**Response Package to NRC's Requests  
for Additional Information**

**Topical Report MUAP-07012-P(R0)  
LOCA Mass and Energy Release Analysis  
Code Applicability Report for US-APWR**

April 2008  
(Non-Proprietary)

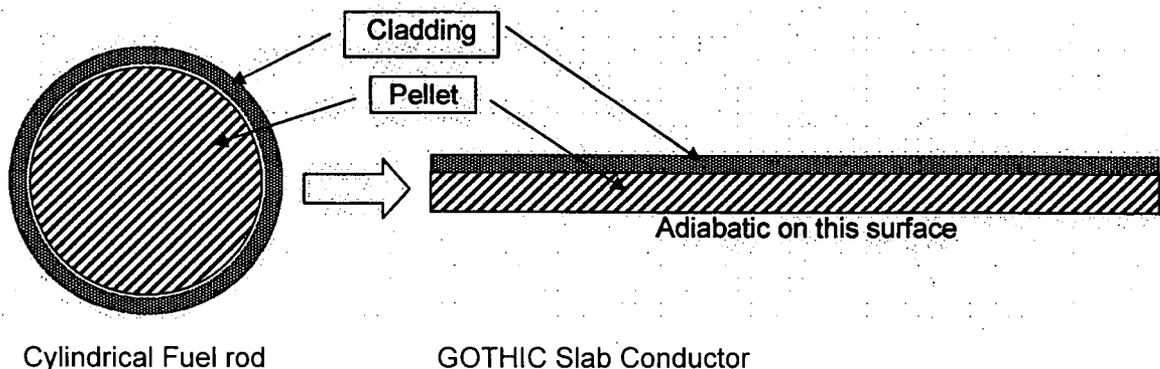
On page 3-14 it is stated that the fuel rods are modeled as a single WALL type conductor with a thickness specified to include the total mass of the fuel. Please describe how the fuel rods, including the cladding, are represented in the GOTHIC model in greater detail. Justify that it is conservative to model the cylindrical fuel rods with slab geometry and that the sensible heat in the fuel rods is released to the containment in a conservative manner.

The following figure of the cross section of the fuel illustrates how a fuel rod, including the cladding, is represented in the GOTHIC model. The slab conductor is defined such that the surface area exposed to the fluid and the mass of each material are preserved. Compared to the cylindrical rod geometry, the slab geometry has a shorter effective conduction length which results in a faster (conservative) release of the stored energy in the fuel.

Since the core has quenched and is covered, the energy to be released is from the decay power generation and a small amount of stored energy as the pressure slowly changes. Therefore, the exact core geometry is less important.

The following parameters from calculated results are shown in Figure 11-k-2 to Figure 11-k-7 in comparison to the base case.

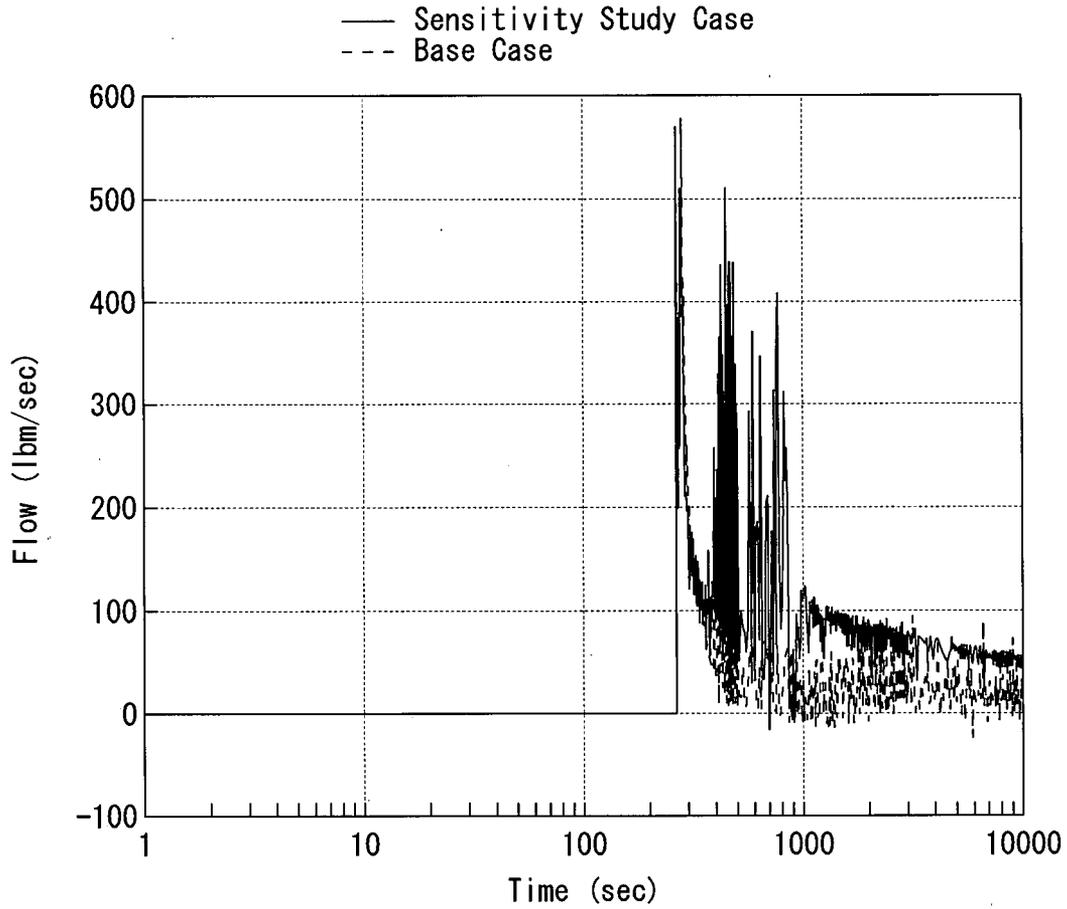
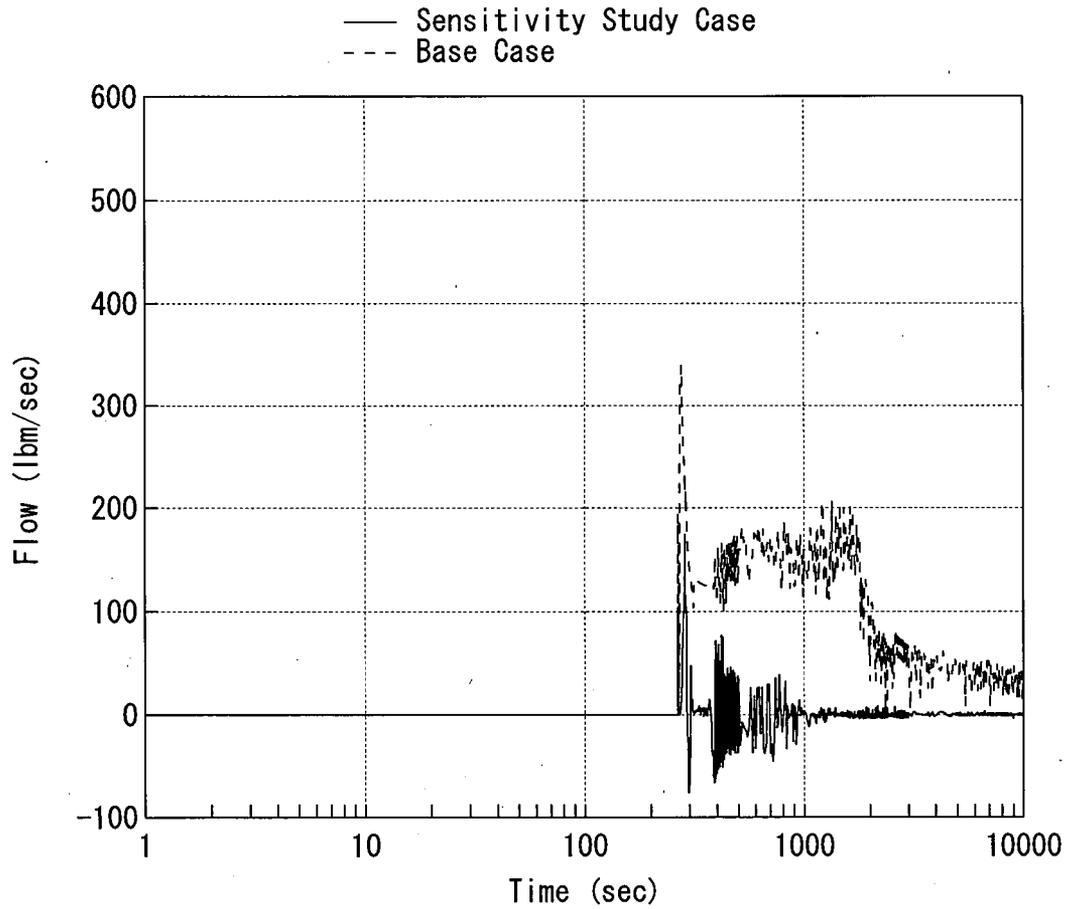
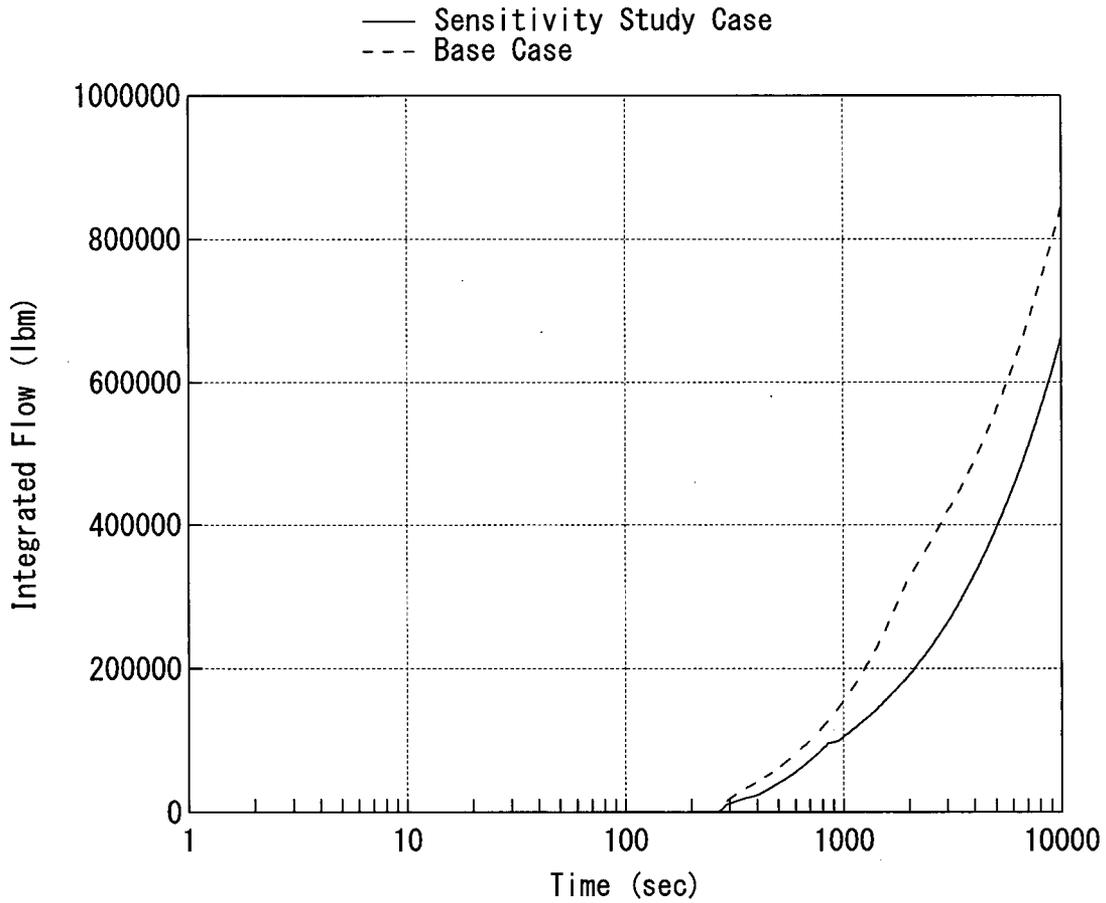
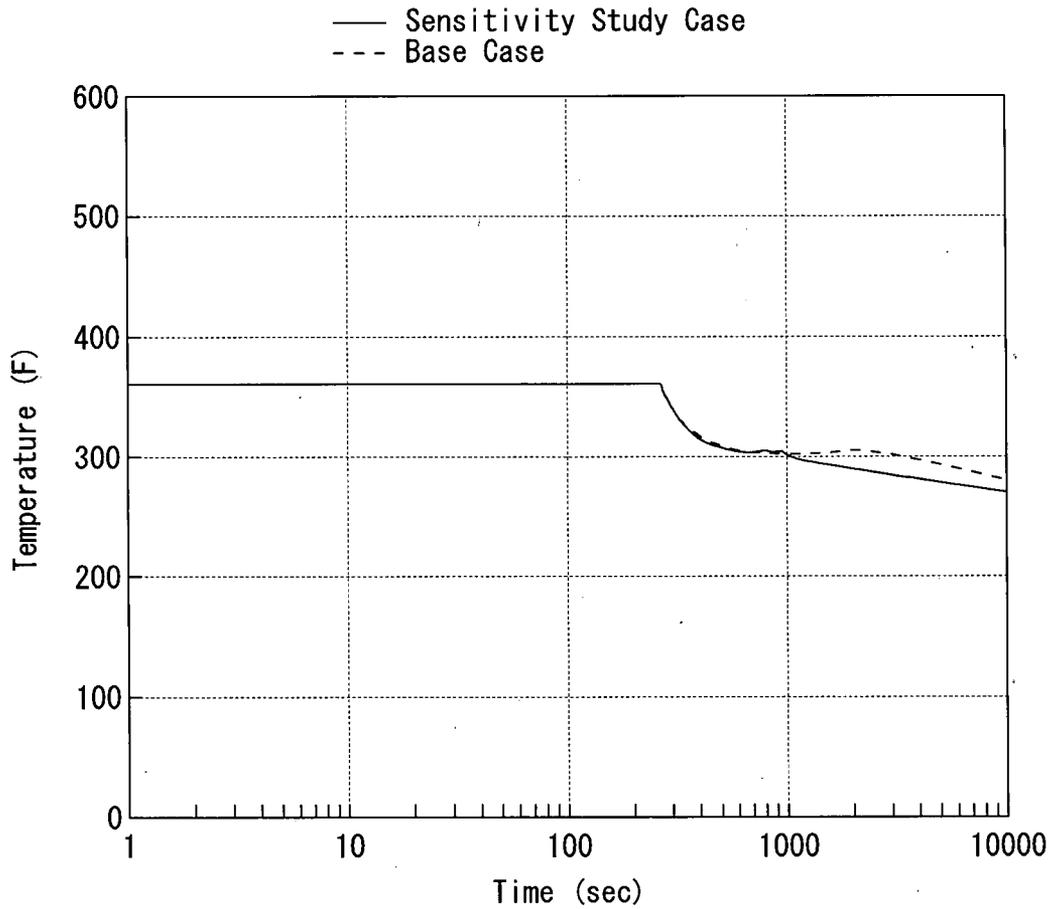
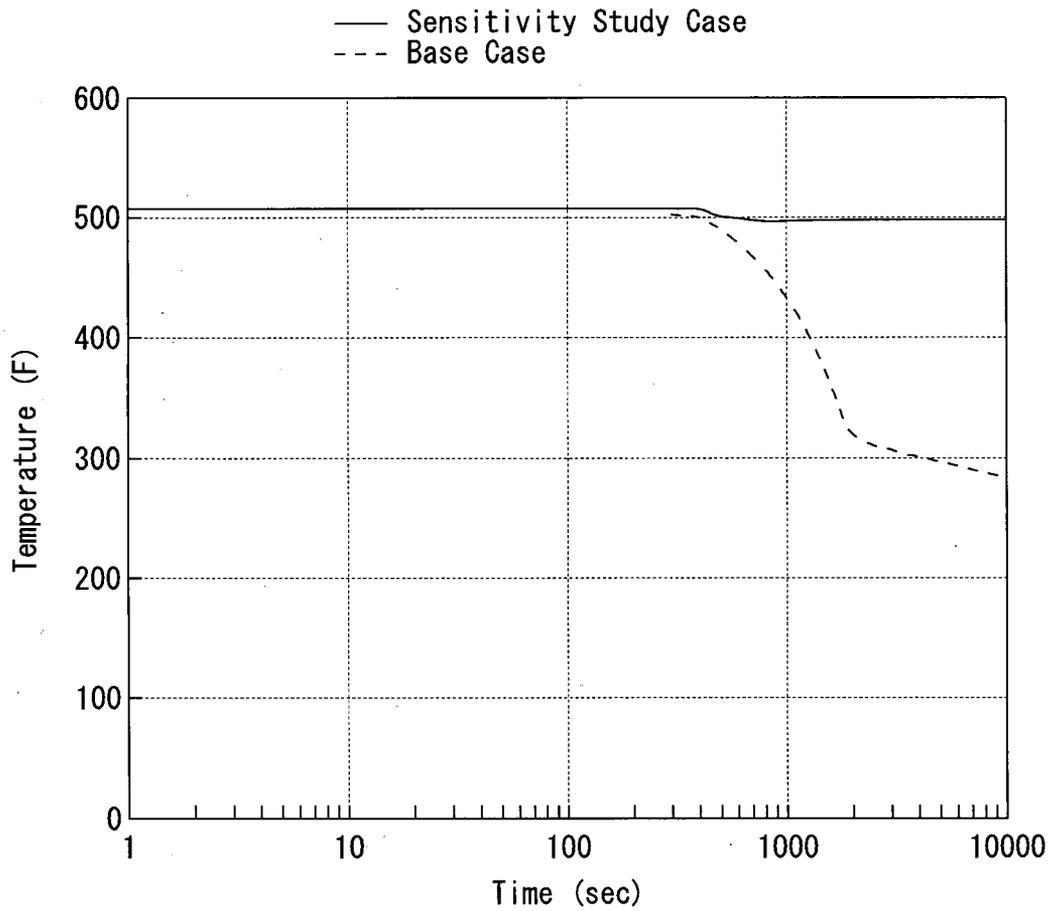
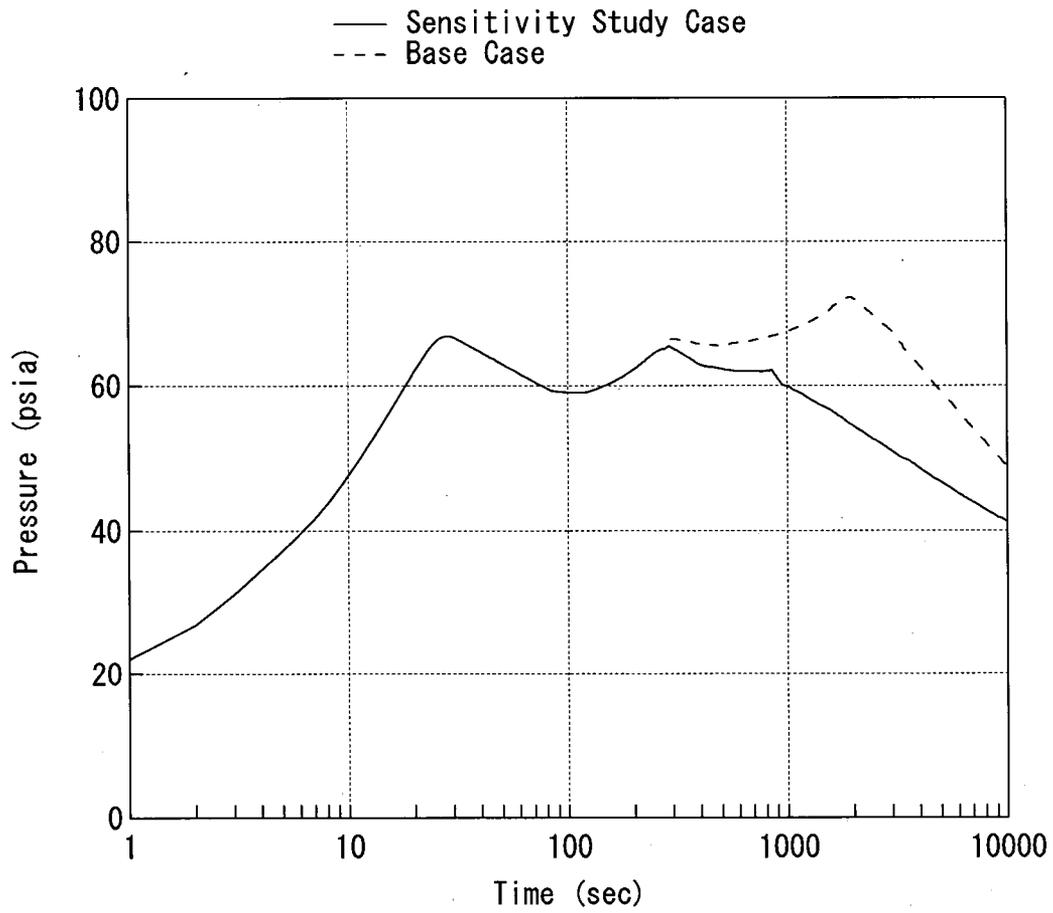
In long term cooling analyses using RELAP5, the staff has found that the loop seals at the reactor coolant pump suction close by being refilled with water. This water comes either from liquid carryover out of the core or from backflow of ECCS in the cold legs. During the blowdown period all the loop seals are calculated to open but during the post-reflood period the loop seals begin to close until only one loop seal is left open. Flow through a single loop is adequate to remove the steam produced by the core and provide for core cooling. The staff's concern is that if following a double ended pump suction break, if all the steam flow is through the broken loop, the steam will not pass through any ECCS injection points and will enter the containment through the break without any steam quenching occurring. As a sensitivity study, please provide an analysis of the containment pressure if three coolant loops were blocked during the post-reflood period and only the broken loop were open to pass steam.

- Break steam flow from broken loop SG side (Figure 11-k-2)
- Break steam flow from broken loop RCP side (Figure 11-k-3)
- Integral of total steam flow to the containment (Figure 11-k-4)
- Broken loop SG secondary side temperature (Figure 11-k-5)
- Intact loop SG secondary side temperature (Figure 11-k-6)
- Containment pressure (Figure 11-k-7)

For the sensitivity case, almost all steam generated in the core flows into the broken loop and the net steam release from the RCP side break is almost zero, as shown in Figures 11-k-2 and 11-k-3. On the other hand, the steam release from the RCP side for the base case is quite large because of the generated steam in the intact-loop SG tubes, as described below. As a result, total steam flow to the containment for the sensitivity case is much smaller than the base case as shown in Figure 11-k-4.

The secondary side temperature of the broken loop SG and intact loop SG are shown in Figure 11-k-5 and Figure 11-k-6, respectively. Cooldown of the broken loop SG secondary side is faster than the base case, but the intact loop SG secondary side, which has much more energy than broken loop SG, is only slightly cooled due to the oscillatory flow through the intact hot leg. The net result is much slower energy release to the containment and the containment pressure during post-reflood phase is much lower than the base case as shown in Figure 11-k-7.
